Implementation of Directive 2009/31/EC on the Geological Storage of Carbon Dioxide

European Technology Platform for Zero Emission Fossil Fuel Power Plants (ZEP) response to the consultation on the draft guidance documents of 17th June 2010

28th July 2010

Site Characterization Workflow

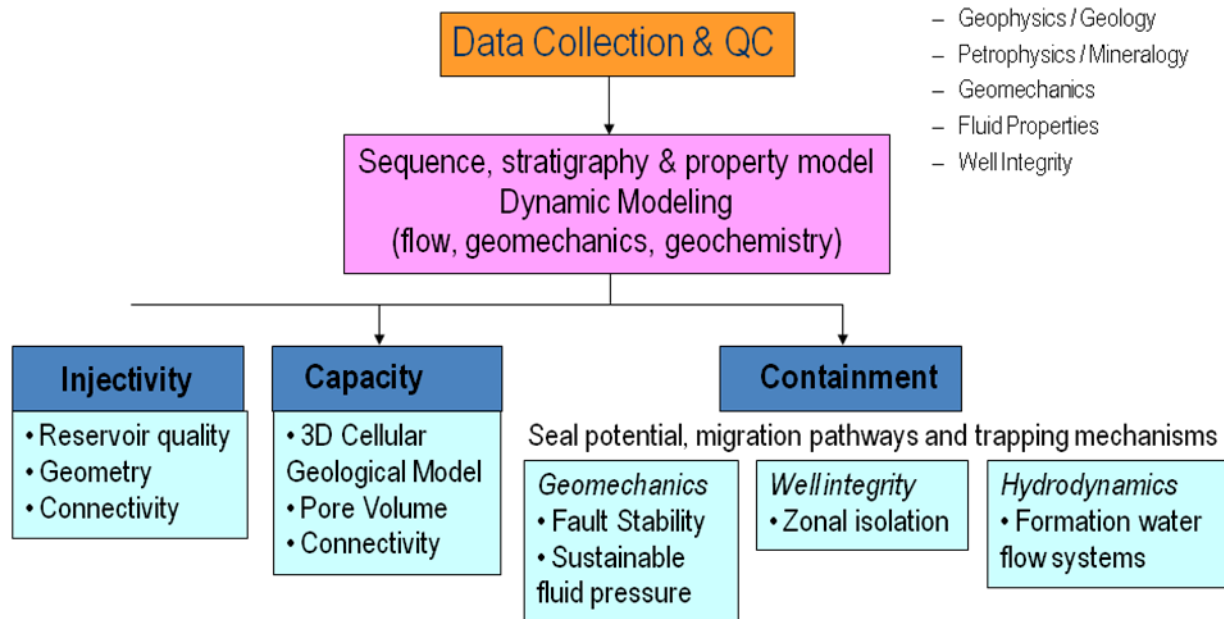
The site characterisation chapter is based on Figure 2. This figure is by no means a workflow but merely a shopping list of data acquisition, modelling and evaluation activities with a myriad of interconnections. Presenting the figure as such may be confusing to the CA. The characterisation workflow needs to go from regional to local, from evaluation of non intrusive surveys to well planning for exploration and monitoring, and then interpretation of data for the design of static and dynamic models.

Workflow could be tailored made to each project, but one type of workflow which could be used is the one developed by CO2CRC for Latrobe (below). It organises the characterisation along the 4 main goals/criteria of capacity, injectivity, containment and monitorability (static model then dynamic model).

Please note that the final figure shall also include “monitorability” in addition to “injectivity”, “capacity” and “containment”.
